## PRODUCT/PROCESS CHANGE NOTICE (PCN)

<b>PCN #:</b> WP1805-01 <b>DATE:</b> June 27, 2018 <b>Product Affected:</b> P9320S-1AHGI P9320S-1AHGI8  <b>Date Effective:</b> September 27, 2018	<b>MEANS OF DISTINGUISHING CHANGED DEVICES:</b> <input checked="" type="checkbox"/> Product Mark <span style="border: 1px solid black; padding: 2px;">YA or ZA on marking</span> <input type="checkbox"/> Back Mark <input type="checkbox"/> Date Code <input type="checkbox"/> Other
---	---

### ATTACHMENT 1 - PCN #: WP1805-01

**PCN Type:** Die Revision Change

Figure 1: Mark Diagram for Product built with New Die Revision.

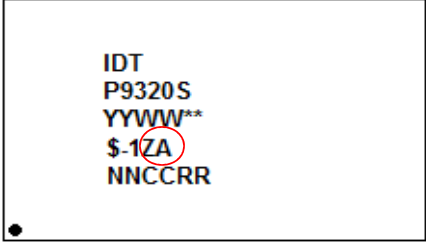
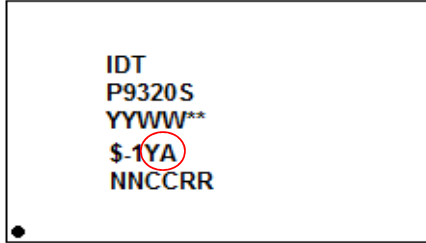
There is no change to the orderable part number. Products from the new die revision is identifiable through product marking as depicted in Figure 1.

New metal revision P9320S-1 , Fab8	New metal revision P9320S-1 , Fab6
